Access Compliance Report

Public Rights-of-Way

(Curb Ramps)

| Intersection ID: N/A | Main Street: OUTLETS_BV | Cross Street: DESIGNER_DR | Location: NW |

| ADA ID: 6BDD1D1C89CF | Ramp Type: PerpDiag | Initial Pass/Fail: Fail | Overall Compliance: No |

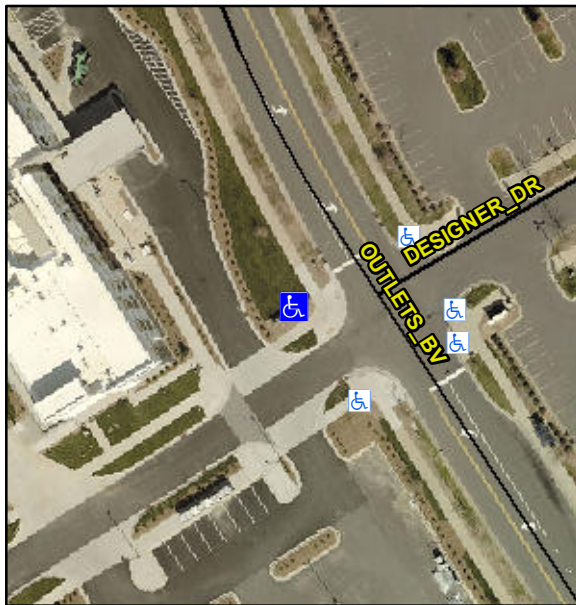
Possible Solutions:

Remove & Replace Curb Ramp With Two New Directional Ramps or Equivalent.

R304.5.1, R304.5.3

| Compliance | Description | Data | Compliance | Description | Data |
|------------|-----------------------|------|------------|-----------------------------|------|
| No | Ramp Width (in) | 47.5 | No | Ramp XSlope (%) | 2.6 |
